Concordia Building Company
Nantucket Condominiums
700 Waterford Lake Drive Cary, NC

PROJECT:	WOP-05115	DATE	06.16.2017
REVISIONS:			
1	CITY COMMENTS		08.07.17
DRAWN BY:	PWI		
CHECKED BY:	SAB		
CONTENT:	MECHANICAL		
	UNIT PLAN

M4.03

1 UNIT 4
1/4" = 1'-0"

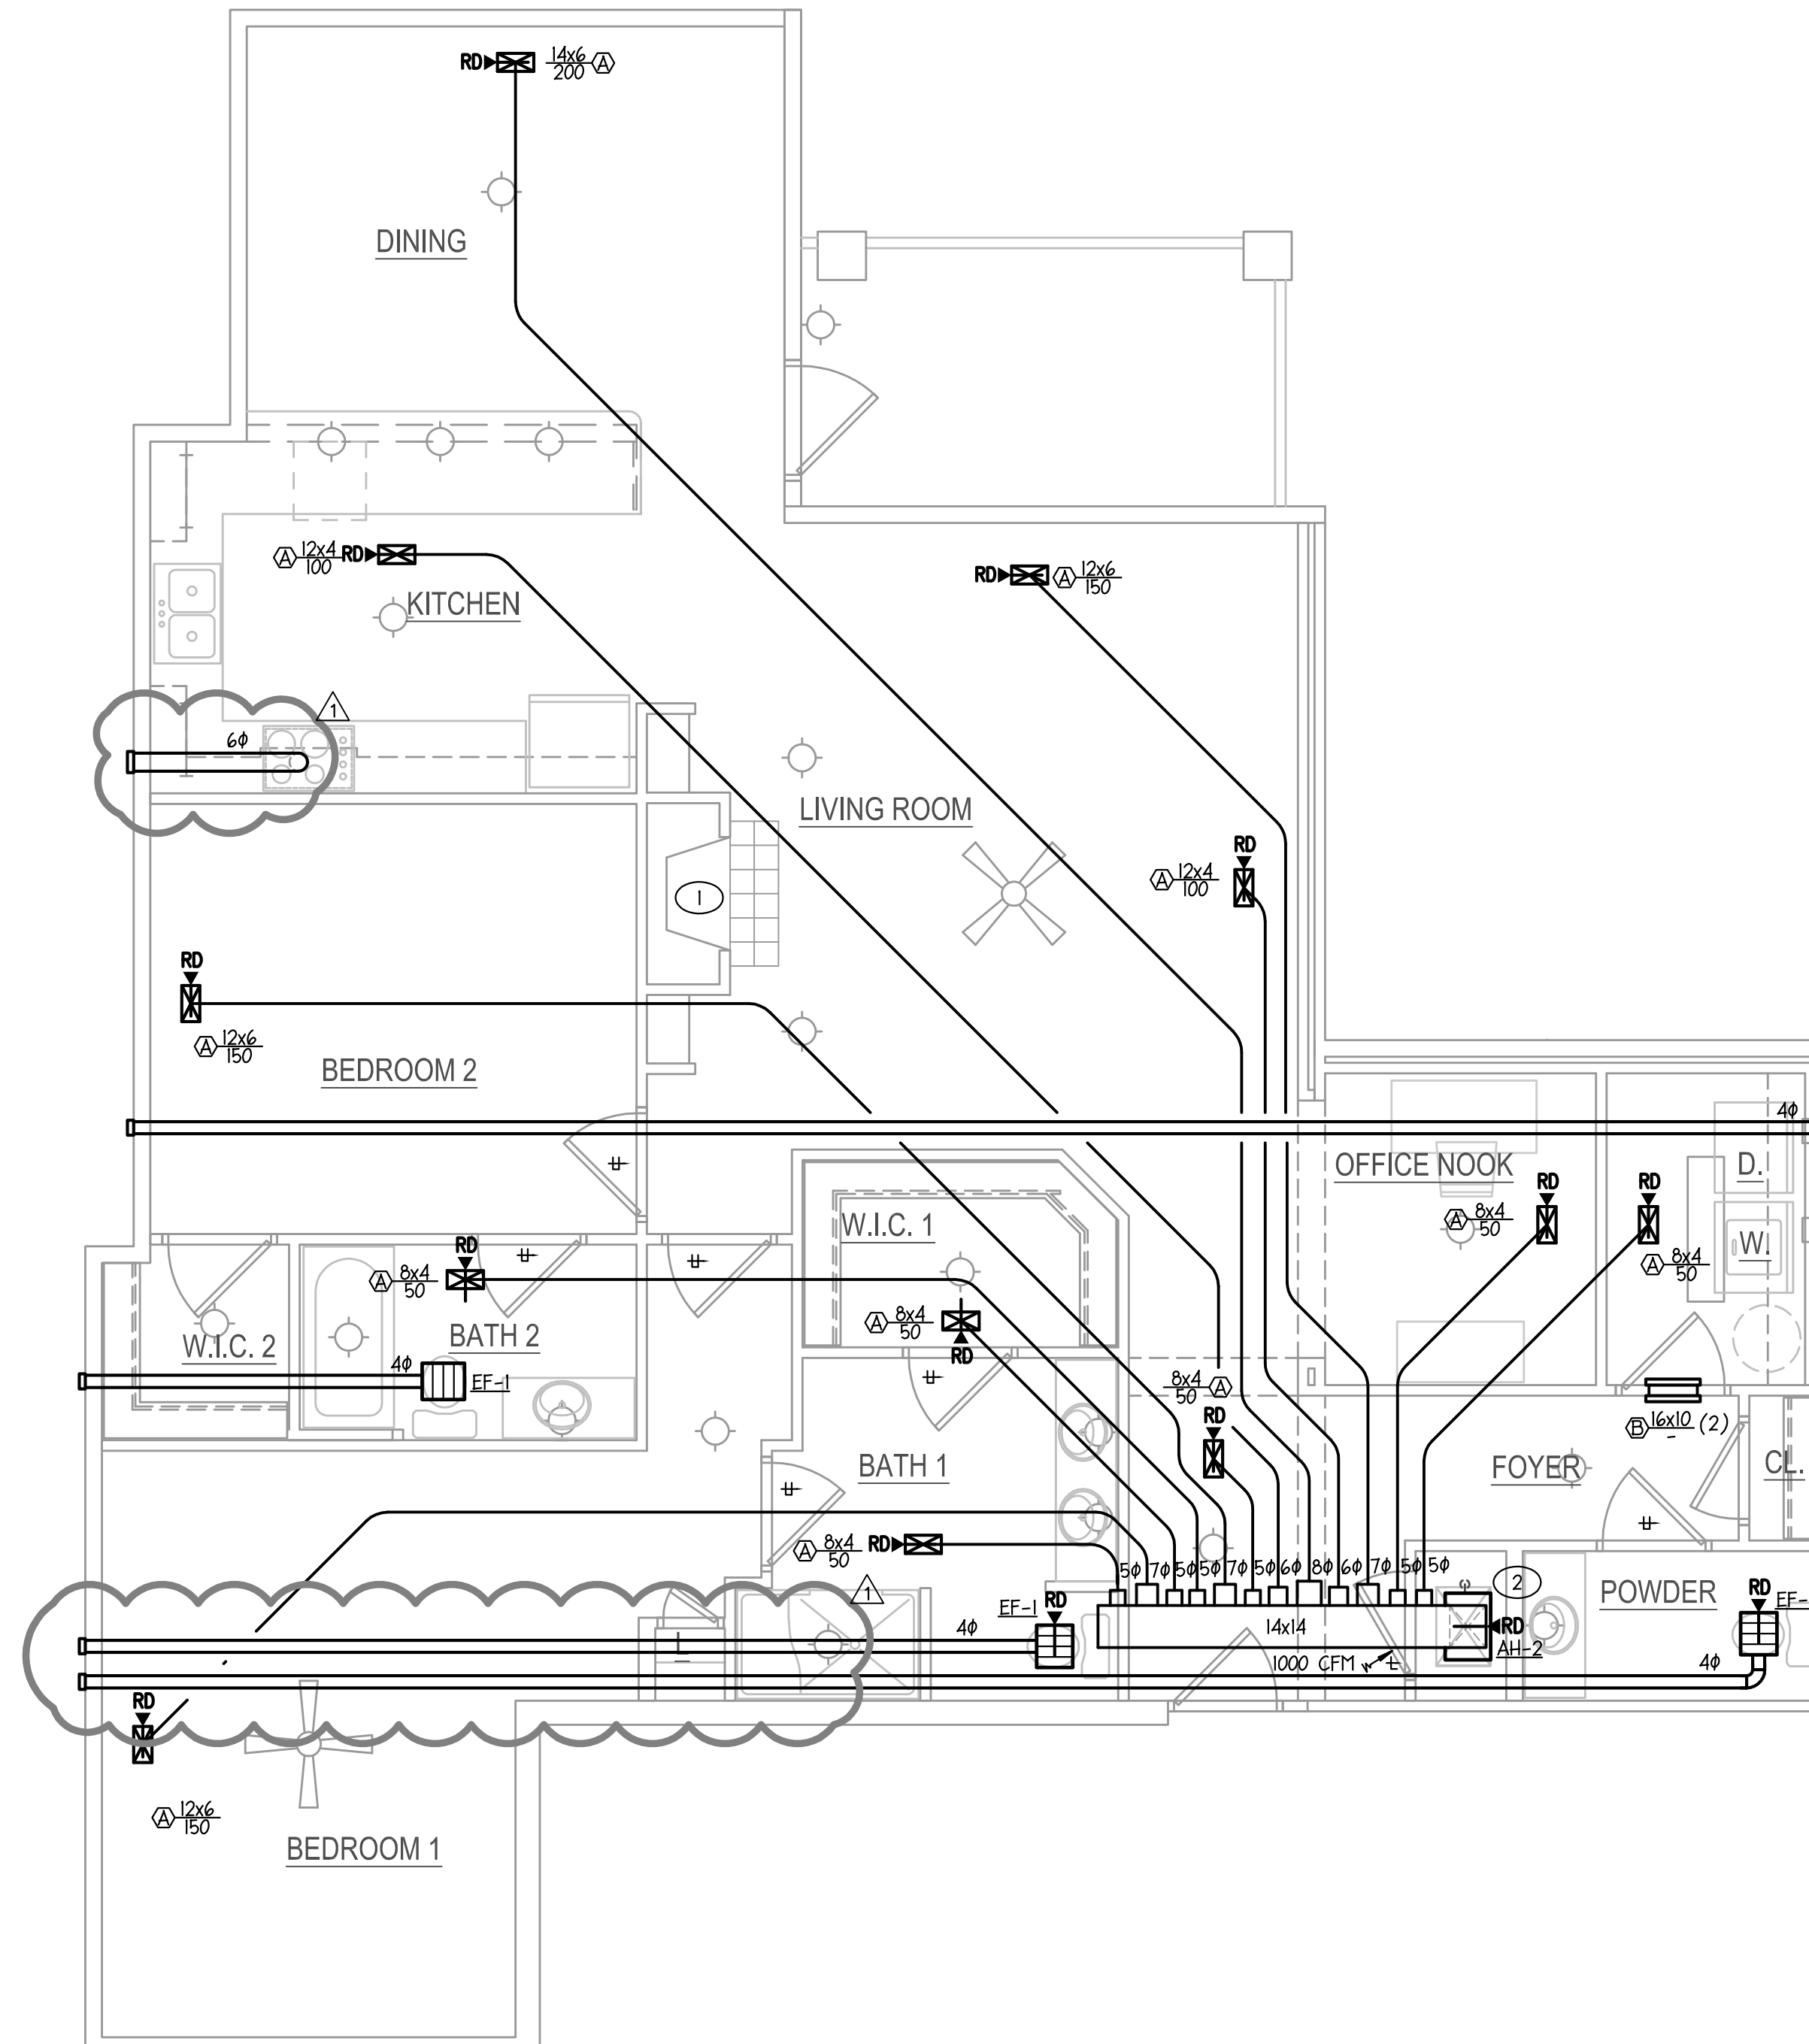
UNITS REARRANGED,
FLEX DUCT REARRANGED
